### ADDENDUM # 2

**Bid 19C15, Design Build for Fire Alarm System at Glade Elementary School**

Project Fire/Security Monitoring	Sheet 1
Date 5/30/2019	
Scale 1/16" = 1'

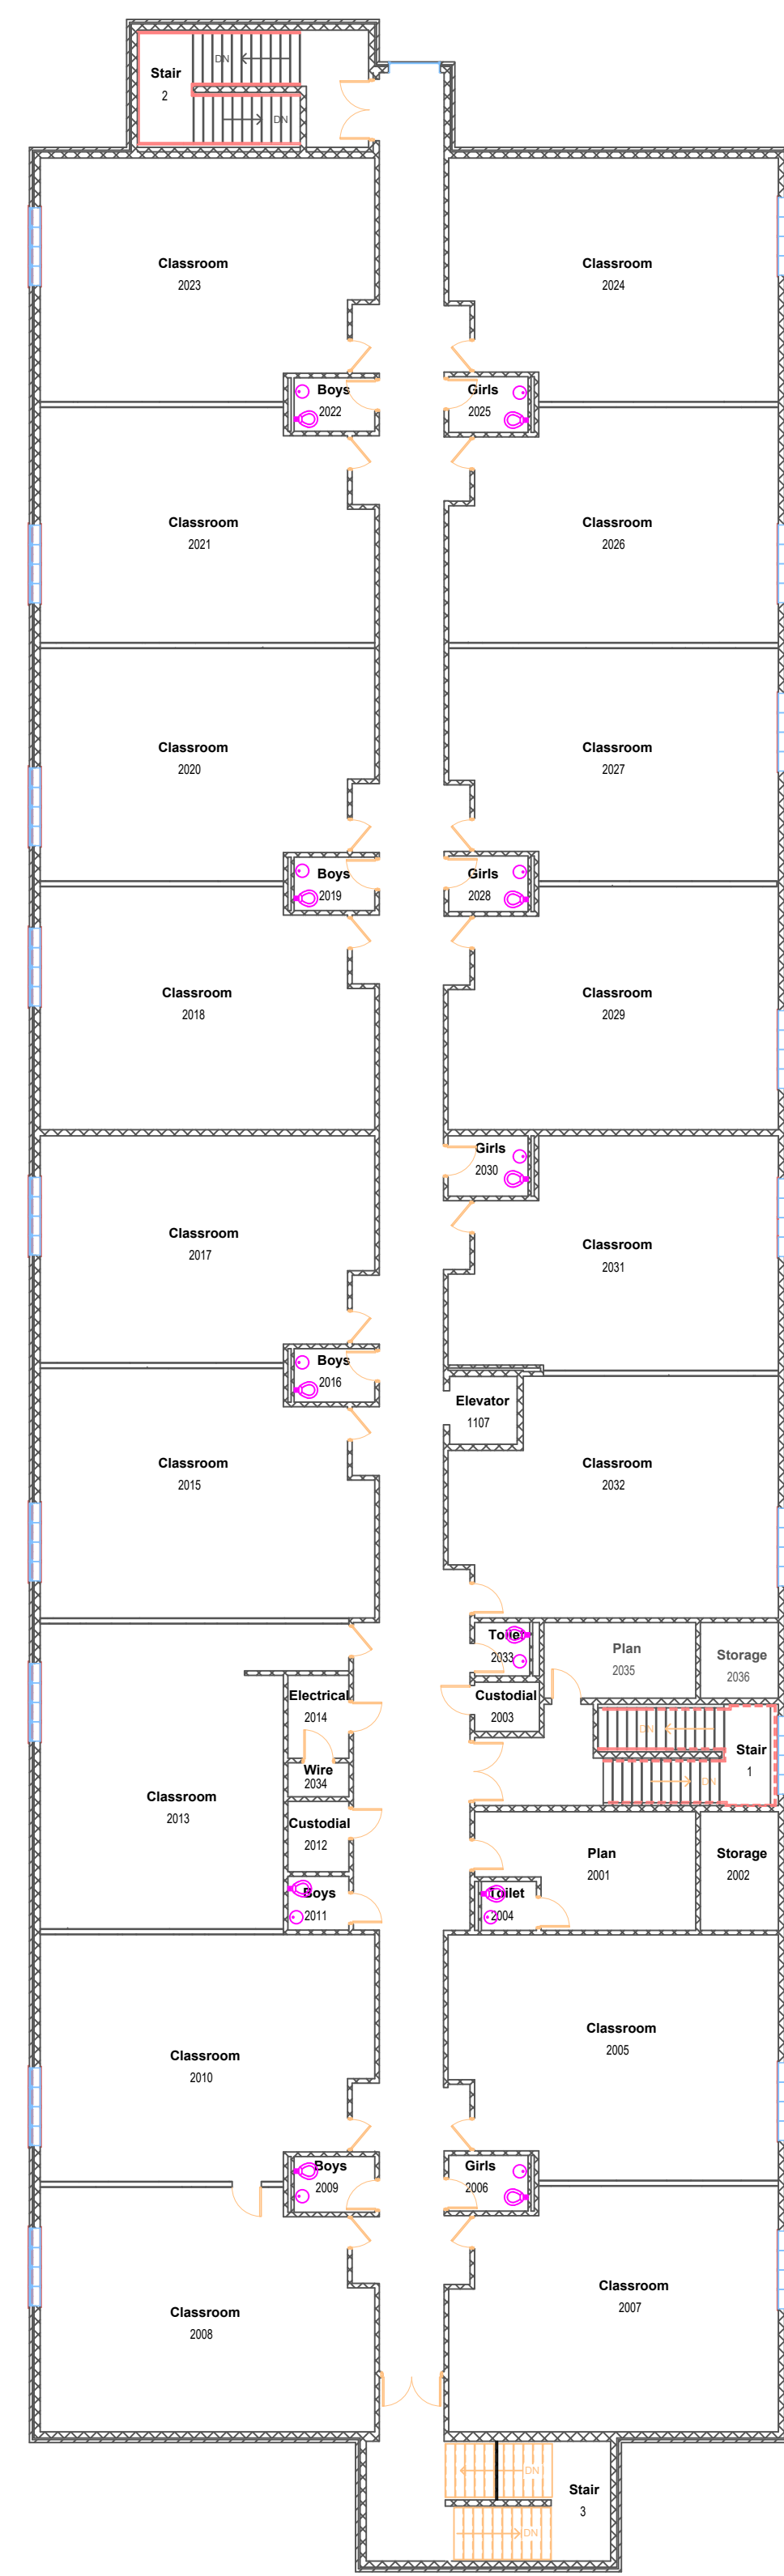
3. Question: Section 1.10 Section B, Item 2 G. Please confirm the Siamese connection location and type of exterior water flow alarm device required. **Answer: Siamese connection and water flow device identified on Addenda drawing.**

18. Question: Please confirm that FCPS will provide the nomenclature for exterior doors prior to contract award. This nomenclature will affect the fire alarm system device labeling, submittals, and monitoring points list. **Answer: The door descriptions are identified on the addendum drawing.**
